**Corrective Action Plan for
Expanded Bioventing System
Site SS-41
Former Building 93 (Fuel Pumping Station No. 3)**

**Charleston Air Force Base
South Carolina**

APPENDIX B
REGULATORY COMMENTS AND
RESPONSE TO COMMENTS

Re: Corrective Action Plan/Expanded Bioventing System
dated November 1996, received January 7, 1997
Former Fuel Pumping Station #3, Bldg. 93 (Site Identification # 15791)
Charleston AFB, SC
Charleston County

Figure 4.1

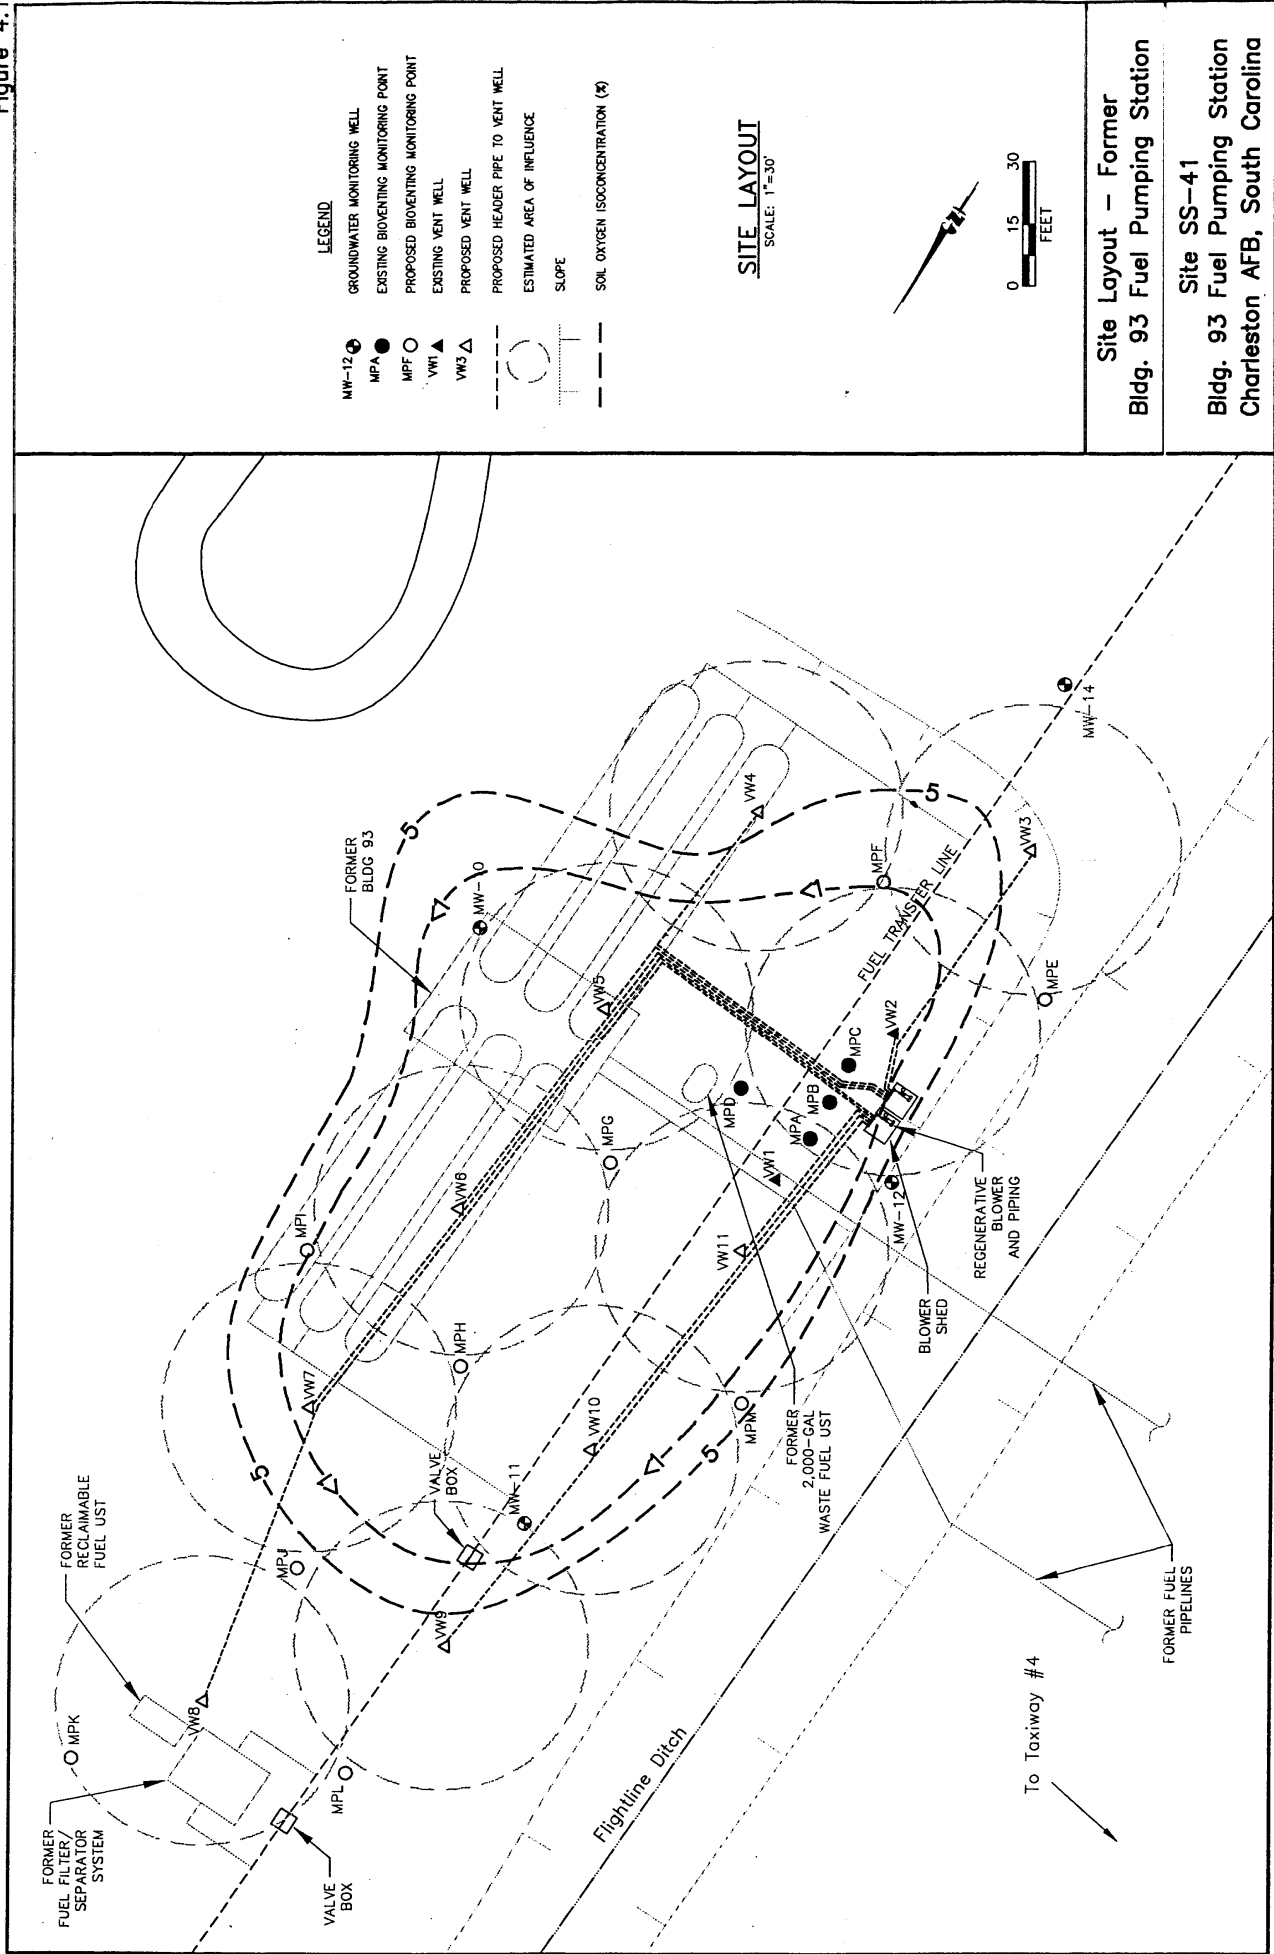
Comment:

Please refer to Figure 4.1 on page 4-4. Also, see the sketch that is provided as part of this attachment. Groundwater monitoring wells MW-10, MW-11, MW-12 and MW-14 are proposed for groundwater analysis.
